AMENDMENT NO.1

Lot 202 Breakwater Drive, Two Rocks

AGREED STRUCTURE PLAN NO.53

AMENDMENT NO.1 TO THE LOT 202 BREAKWATER DRIVE AGREED STRUCTURE PLAN NO. 53

Figure 2 Approved subdivision guide plan

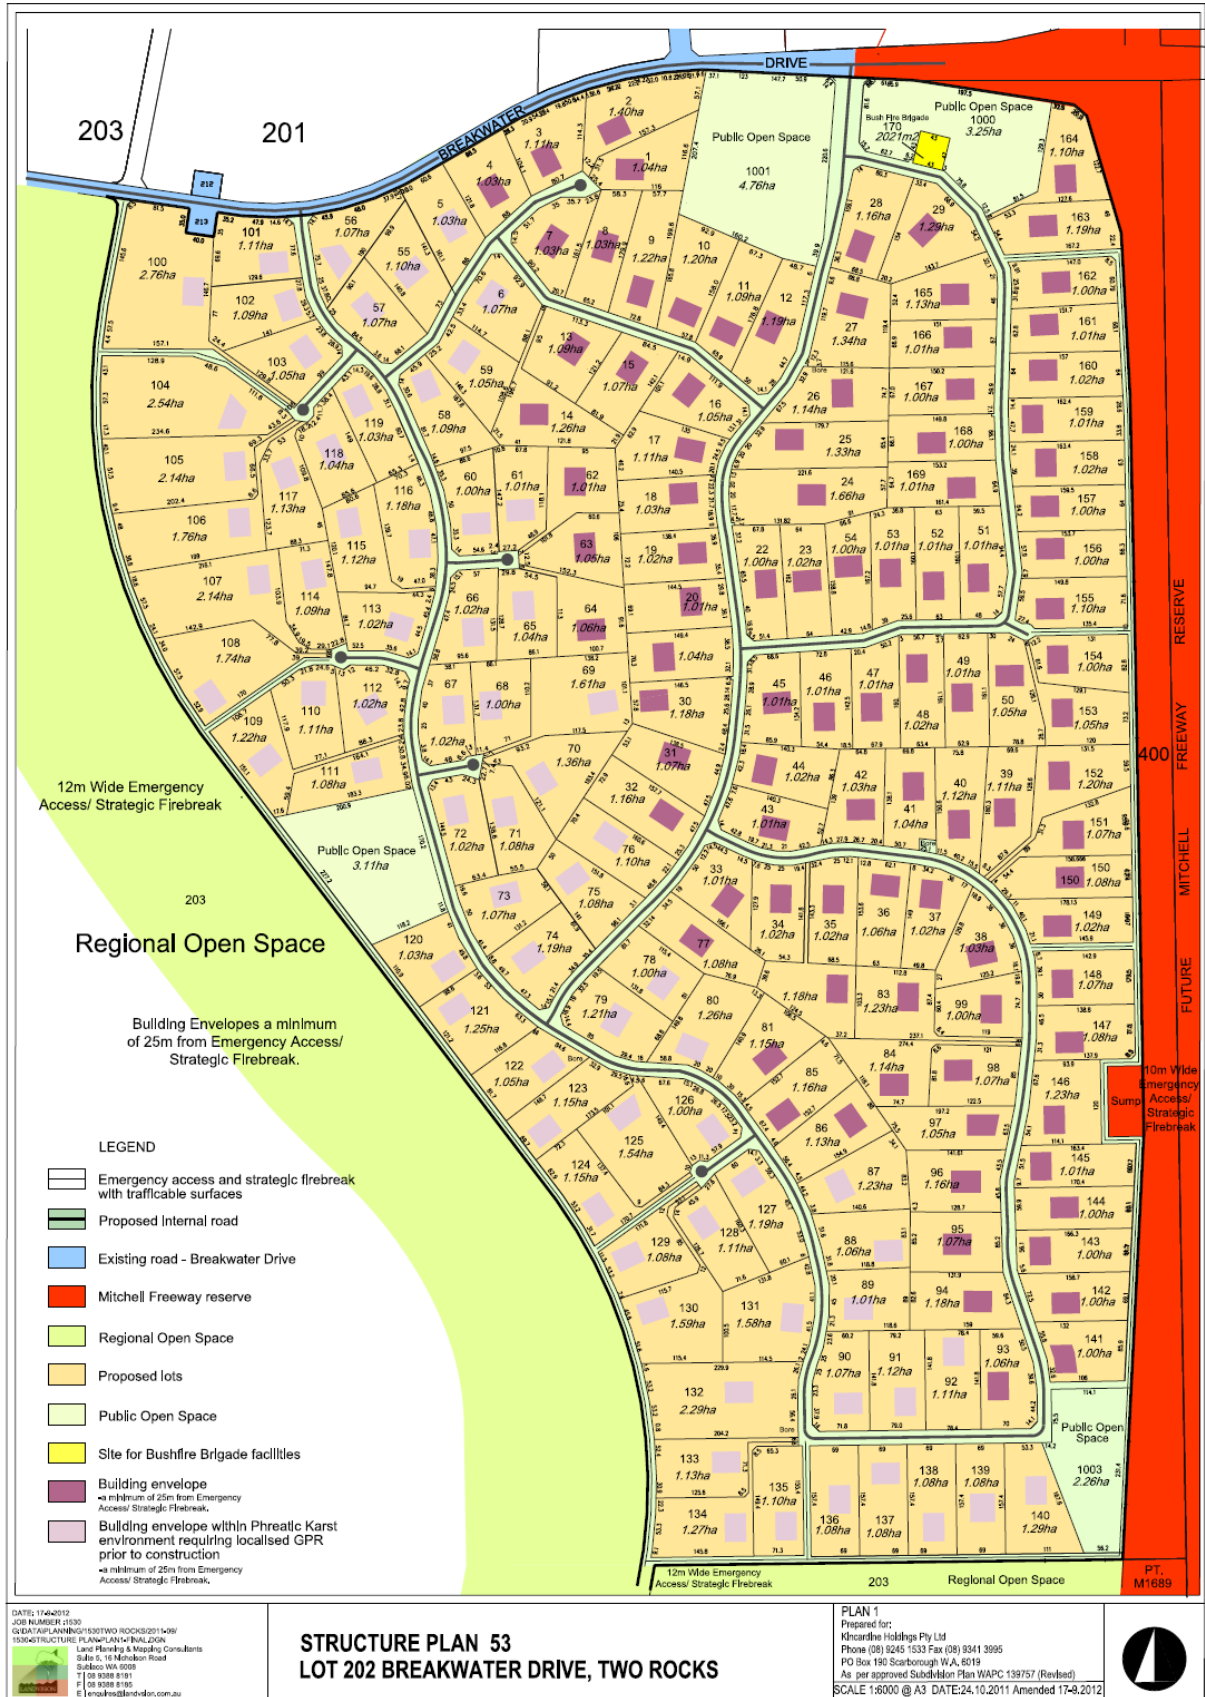
ASP 53 controls the development of the Breakwater Estate on Breakwater Drive in Two Rocks. The Breakwater Estate plan of subdivision (see Figure 2) currently comprises 169 rural residential lots, with a minimum lot size of 1 hectare. The land is zoned 'Rural Community' under the City of Wanneroo's District Planning Scheme No 2 (DPS 2).

The plan of subdivision within the structure plan shows four areas to be set aside for public open space. Two of these have already been set aside and are now under the control of the City of Wanneroo. A third area which contains the Emu Cave site of aboriginal heritage significance is currently going through the process of being developed as a conservation reserve, with a view to being taken over by the City of Wanneroo in approximately two years time.

Figure 5 Proposed plan of subdivision superimposed on current POS area.

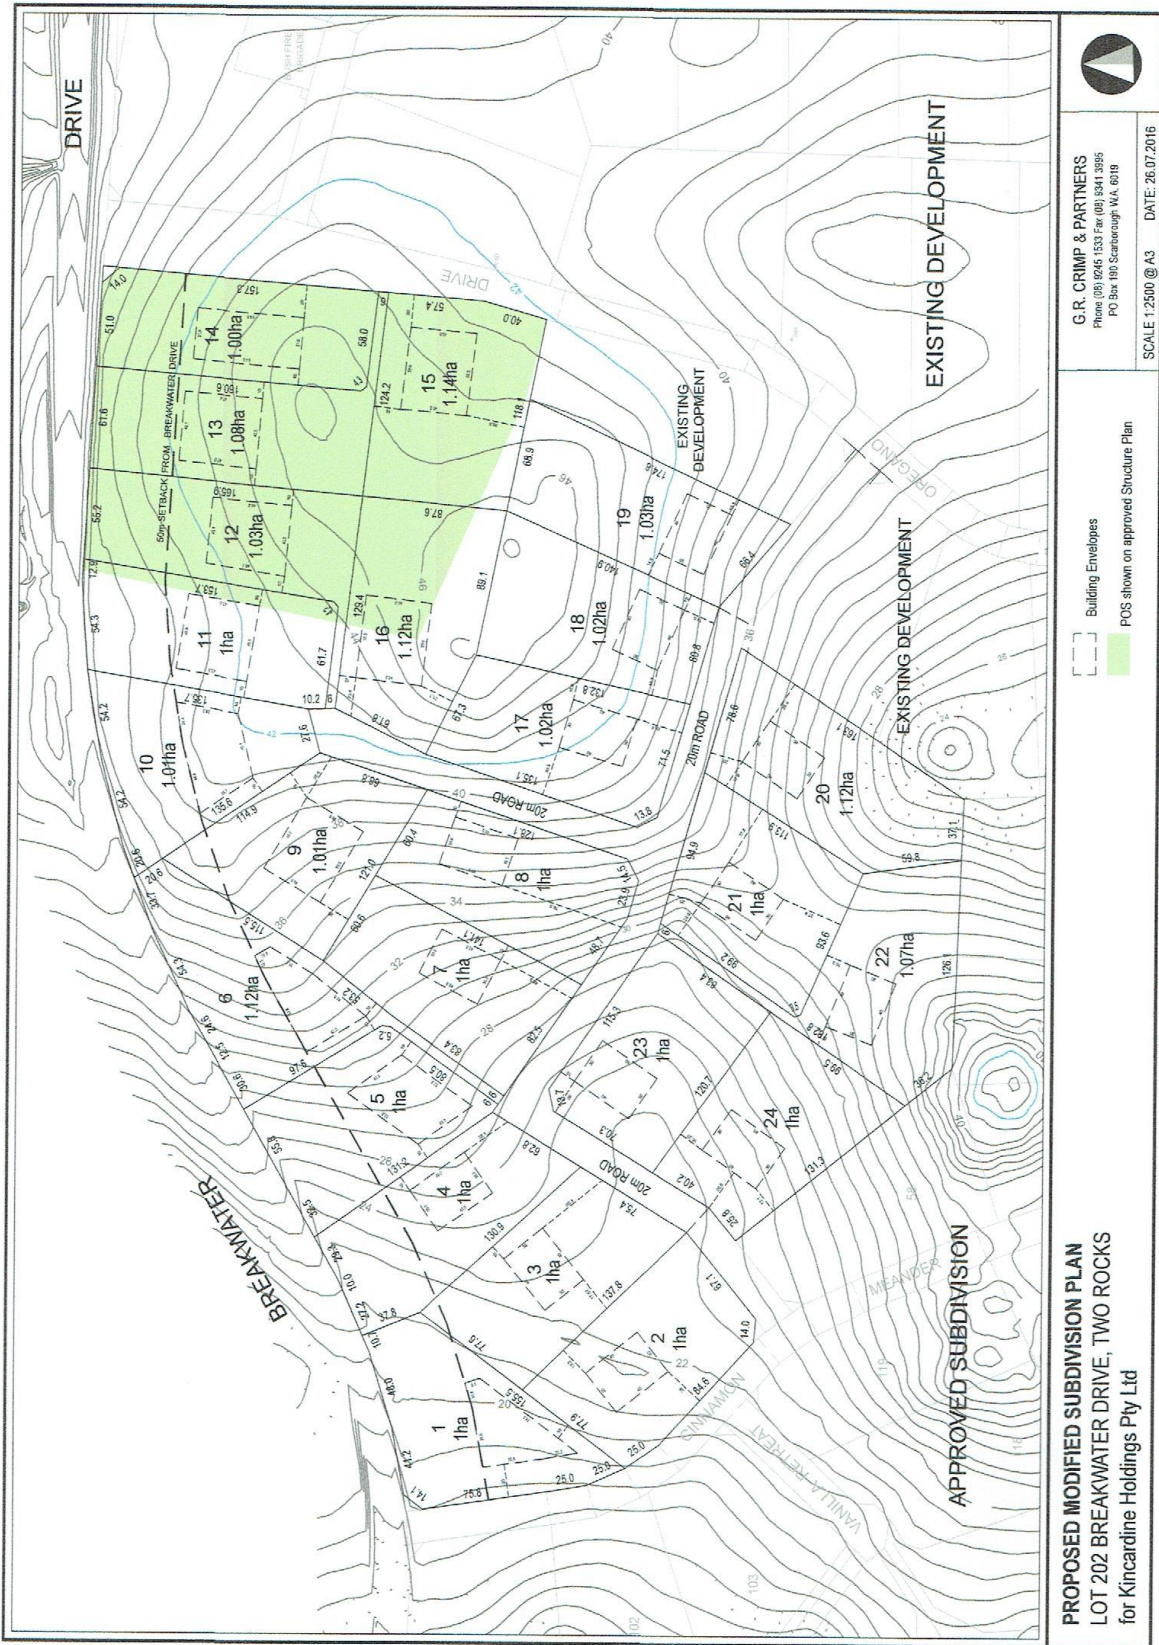
The proposed change to ASP 53 is to amend the plan of subdivision north and west of the currently developed area. This part of the estate includes a 4.76 hectare area shown as public open space, and also affects the following lot numbers as shown on the plan of subdivision: 1-11, 13-15, 55-57. The road layout also is proposed to be reconfigured. The location of the area of the structure plan to be amended is shown on the attached aerial photograph (figure 3). A modified structure plan map is shown at figure 4, and the proposed plan of subdivision superimposed on contour information together with the extent of the existing public open space is shown on figure 5 attached.

The net result of the proposed changes would see the yield in the affected area rise from 18 to 24 lots. Therefore, the lot yield for the entire subdivision will rise from 169 to 175 lots.

The proposed modification to the plan of subdivision in the structure plan includes four lots within the Phreatic Karst area (lots 55-57 and 59) but the building envelopes have not been extended beyond those shown on the existing plan of subdivision.

Figure 6 Original plan of subdivision with three areas of POS identified

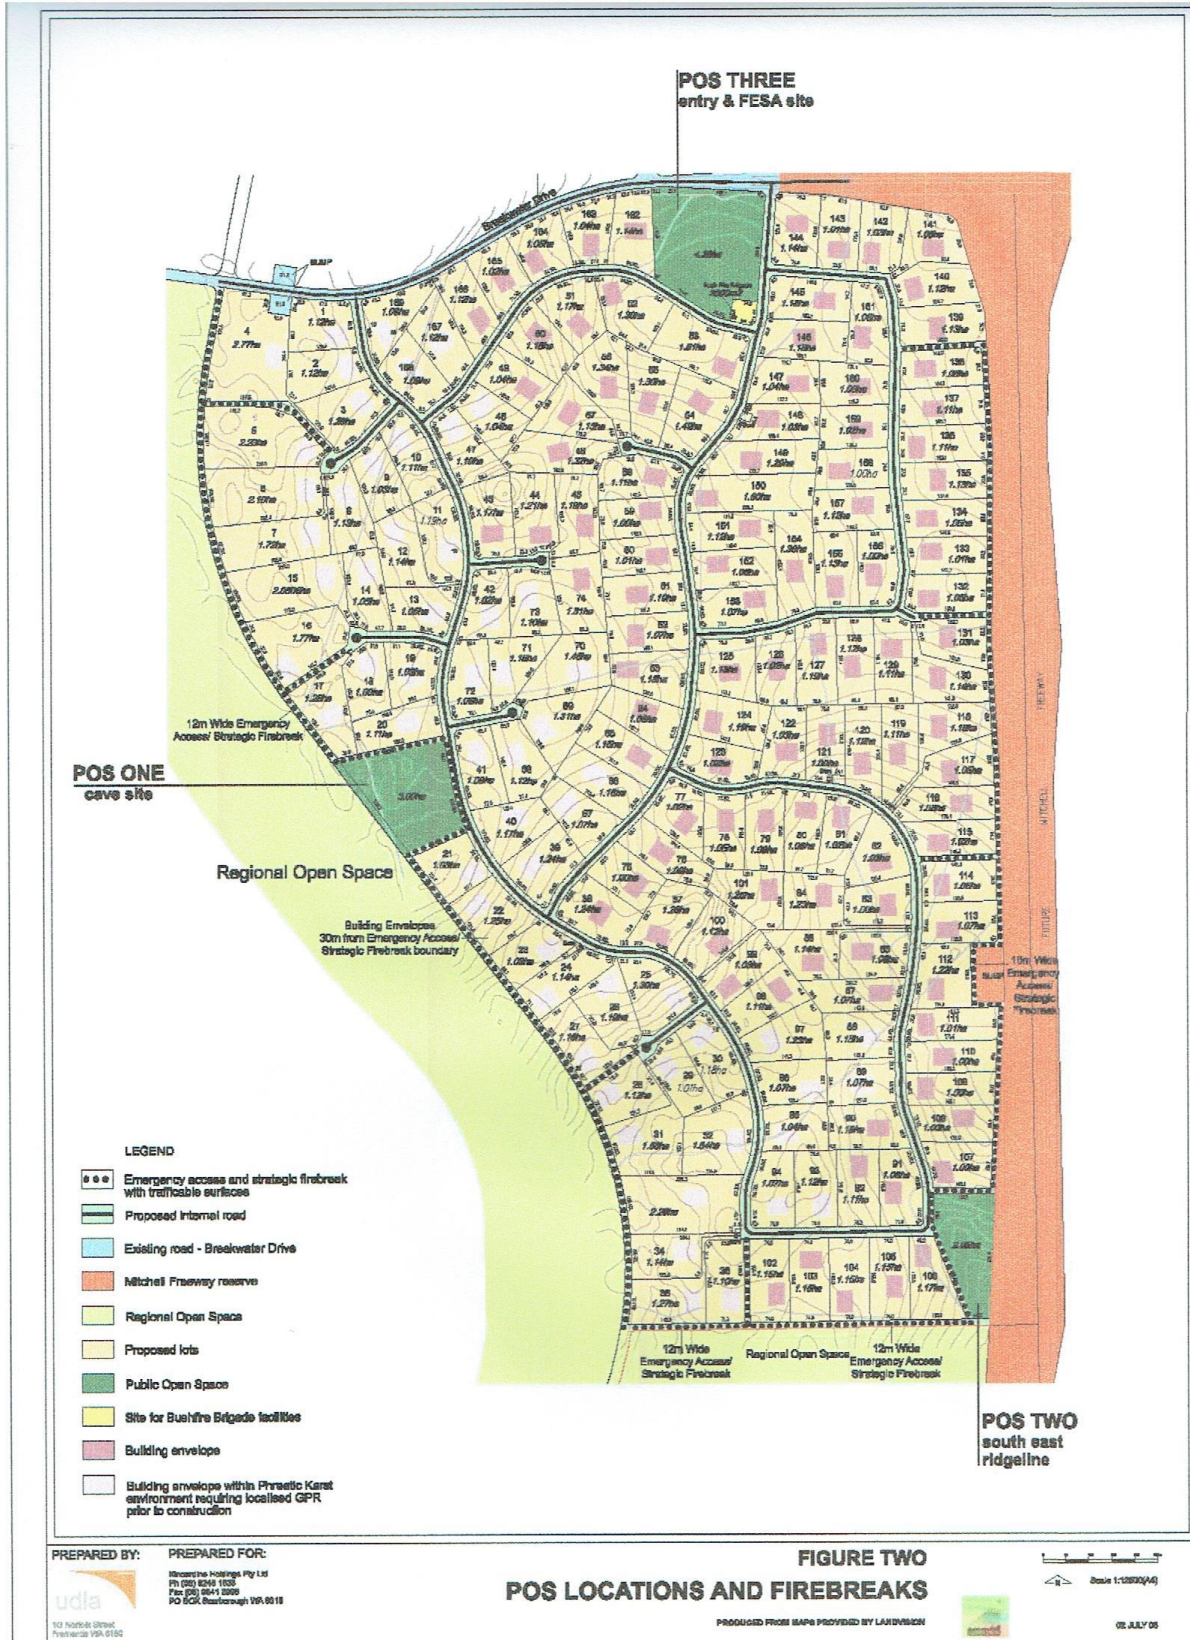
When the original subdivision design was proposed, three POS areas were identified. The largest, at over 4.76 ha, was located on the western side of one of the entrances into the subdivision off Breakwater Drive. This was an area that had been identified by the Department of Fire and Emergency Services (then FESA) as a suitable location for a bushfire fighting facility. It was large enough and clear enough to accommodate a helicopter landing area if needed.

A second area of open space in the far south-eastern corner of the subdivision was identified based on its floristic characteristics. It is over 2 hectares in area. It is also an area where limestone pinnacles are at the surface making it very difficult to develop.

The third area on the western boundary of the estate is an aboriginal heritage site, containing Emu Cave. It is over 3 hectares in area. This is a site used by the local aboriginal group for educational and ceremonial purposes, and is being set aside as a conservation reserve rather than a reserve for recreation.

Therefore, in the original plan of subdivision areas of open space totalling almost 10 hectares were identified.
